RIVERHEAD WATER DISTRICT

**** ADDENDUM NO. 1 ****
SEPTEMBER 22, 2016

Project No.: RDWD 16-02

Project Name: INSTALLATION OF NEW VARIABLE FREQUENCY DRIVES AT PLANT NO. 10 SOUND SHORE ROAD, RIVERHEAD

2 New Single Line Diagram

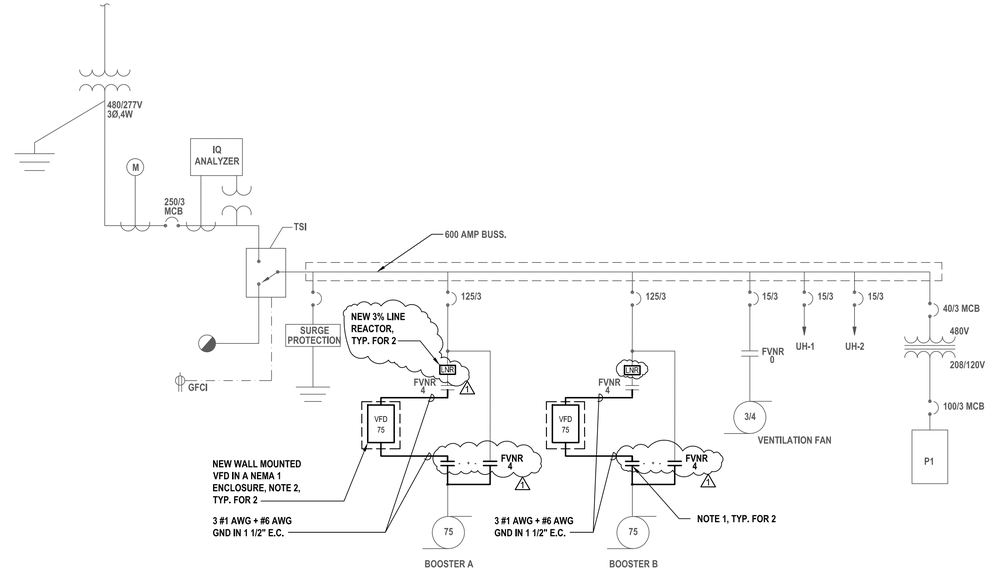
1. Furnish and install a new output and bypass contactor that are factory aligned, mechanically and electrically interlocked.
2. Furnish and install a new line reactor in the existing MCC cubicle.

Contractor shall review revised Sheet E1.0 dated 09.19.2016 for a detailed scope of work required.

1. CONTRACTOR SHALL INSTALL A NEW OUTPUT AND BYPASS CONTACTORS (NEMA 4) IN EXISTING BOOSTER CUBICLE. NEW OUTPUT AND BYPASS CONTACTOR SHALL BE ELECTRICALLY AND MECHANICALLY INTERLOCKED AND SHALL BE INTERFACED WITH NEW VFD. CONTRACTOR SHALL PROVIDE ALL REQUIRED WIRING AND RELAYS.
2. CONTRACTOR SHALL INTEGRATE NEW VFD WITH EXISTING BOOSTER CONTROL CIRCUIT IN EXISTING MCC CUBICLE. CONTRACTOR SHALL PROVIDE ALL REQUIRED COMPONENTS TO INTEGRATE NEW VFD INCLUDING NEW WIRING AND RELAYS AND CONTROLS.
